**DAC 25/07/23 – 21 PARNELL PLACE NEWCASTLE EAST –
DA2022/00705 – MIXED USE - ALTERATIONS AND ADDITIONS TO
EXISTING HOTEL OR MOTEL ACCOMMODATION (NEWCASTLE
BEACH HOTEL), ANCILLARY FOOD AND DRINK PREMISES AND
COMMERCIAL USE (ANCILLARY HOTEL SPA) AND DUAL
OCCUPANCY (ATTACHED 2 X DWELLINGS)**

PARNELL PLACE

21 Parnell Place, Newcastle East, NSW 2300
LOT 1 /DP815595

PROPOSED 1980'S RENOVATION WESTERN ELEVATION

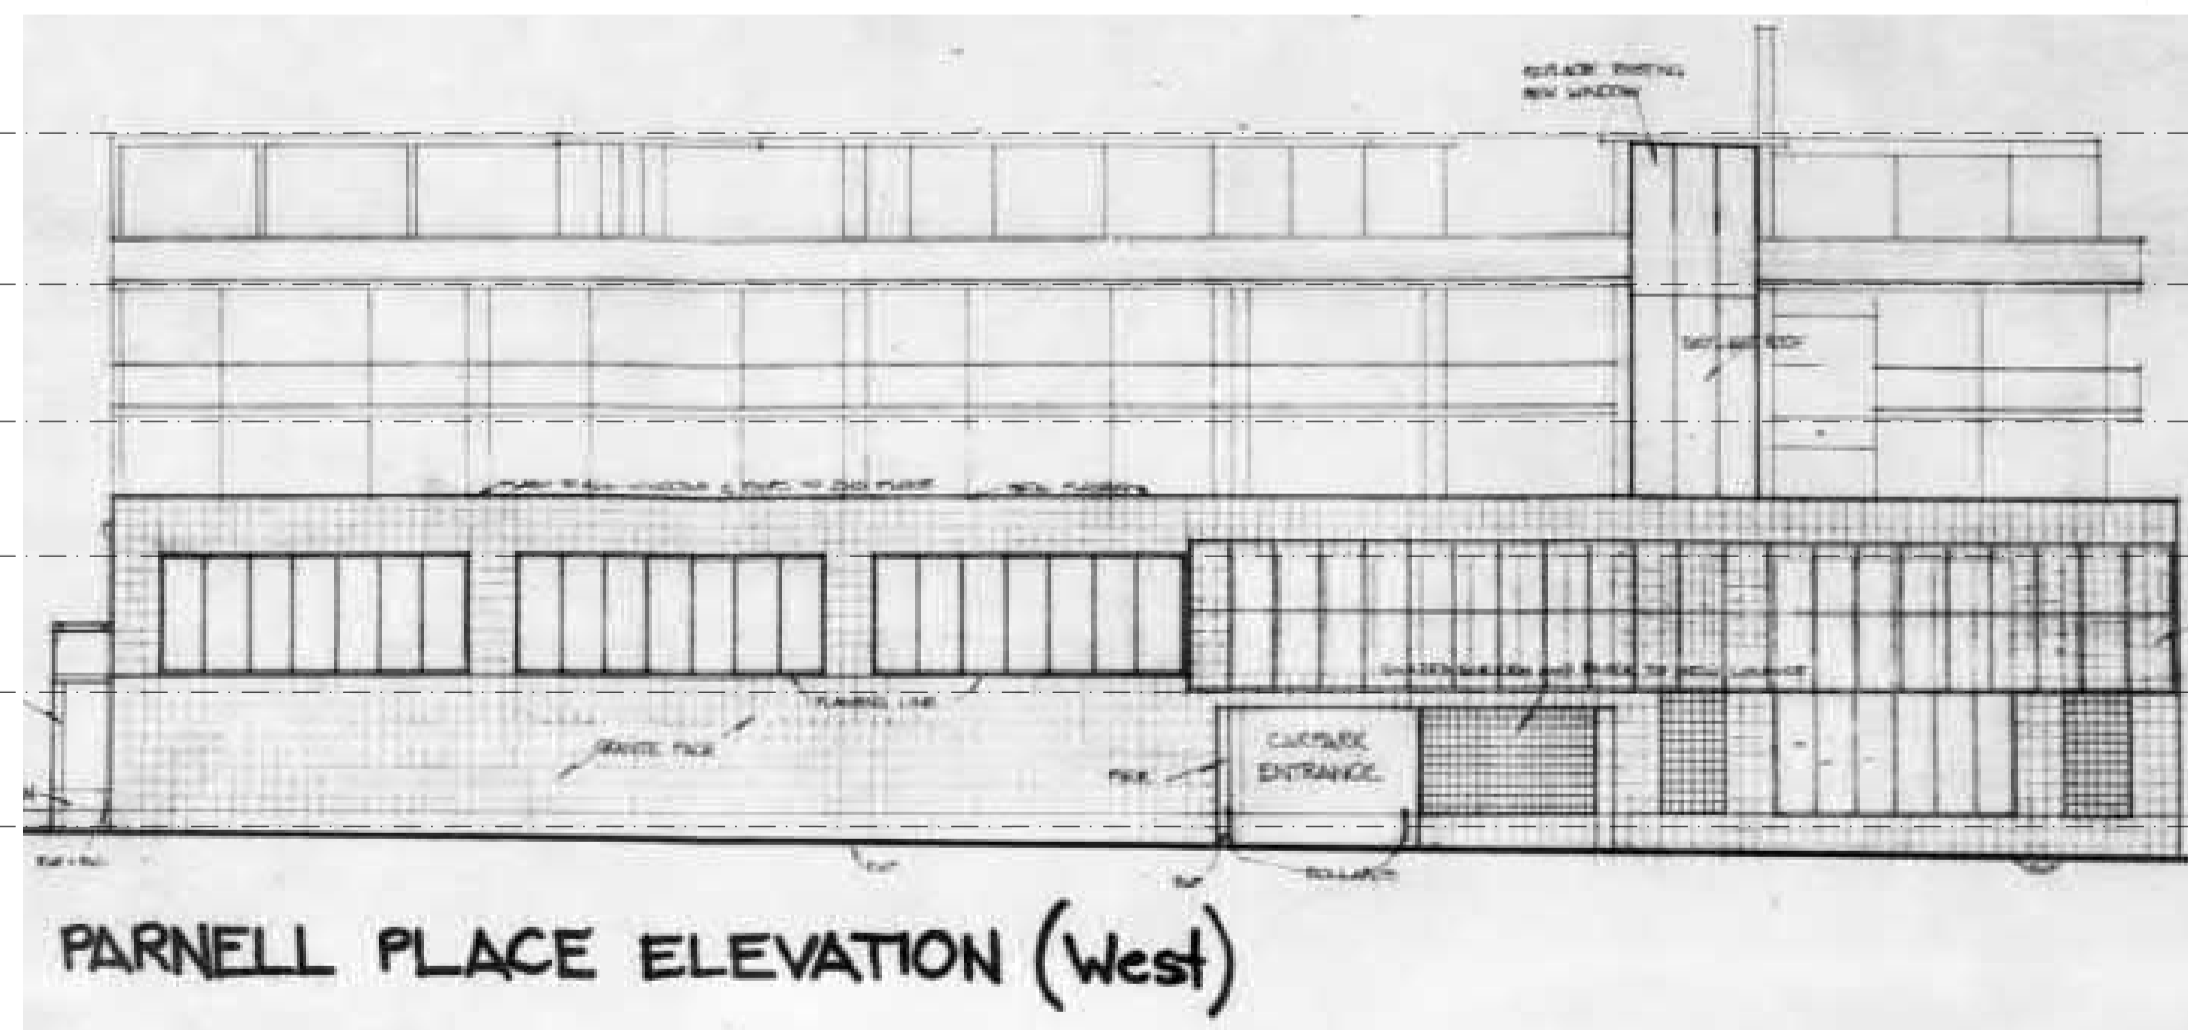
RFI RESPONSE - 13/10/22 & 14/11/22
 - BULK AND SCALE ANALYSIS COMPLETED
 AGAINST EXISTING AND ORIGINAL
 ELEVATIONS

THE EXISTING BUILDING HAS A BALUSTRADE AT LEVEL 4 TO THE WEST WHICH MAINTAINS A SOLID FORM. SINCE WE ARE PROPOSING TO REMOVE THESE SOLID BALUSTRADES AND REPLACE WITH GLASS, WE ARE EFFECTIVELY LOWERING THE DATUM LEVEL AND PERCEIVED BULK
